# **AINSTY (2008) INTERNAL DRAINAGE BOARD**

**Planning Inspectorate Reference:** EN020024  
**Application Description:** Application by National Grid Electricity Transmission (NGET) for an Order Granting Development Consent for the Yorkshire Green Energy Enablement (GREEN) Project

## **Yorkshire GREEN – DC1**

### **Q4.03 Ainsty Internal Drainage Board Response**

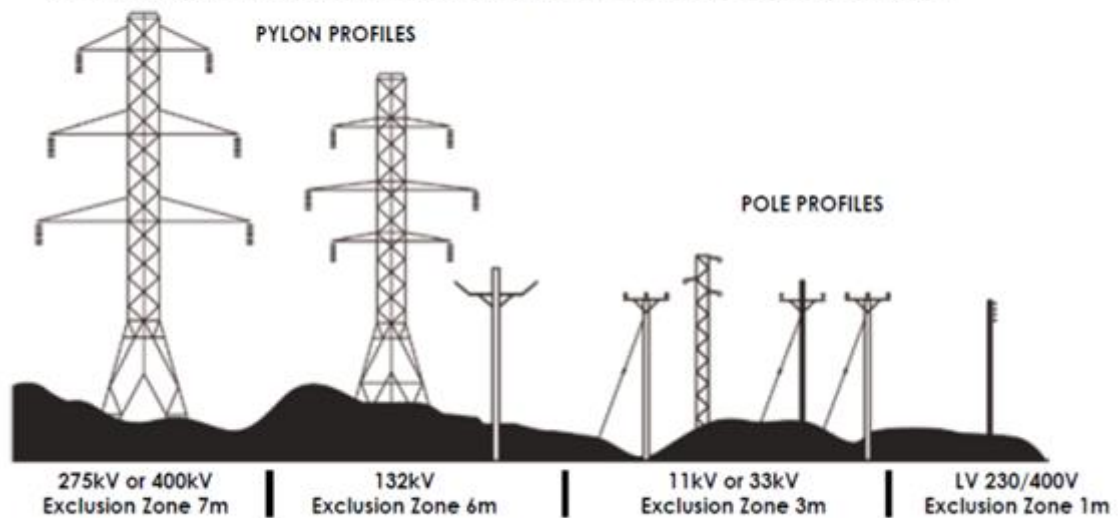
- You must not allow any part of your plant to enter the **EXCLUSION ZONE**.
- The diagram below shows typical types of overhead lines and provides a guide to help assess the line voltage of lines on wooden poles or steel pylons. The minimum **EXCLUSION ZONE DISTANCE** is shown for each example.

- Please note that these are absolute minimum distances that should under no circumstances be infringed. ***If you do - it could prove fatal.***

This clearly states that we should not be letting any part of our equipment in the “Exclusion Zone” and the “Exclusion Zone” for 275kV and 400kV is 7 metres.

The Boards equipment height is 3.5 metres.

This takes us to needing the overhead lines to be 10.5 metres above ground level.
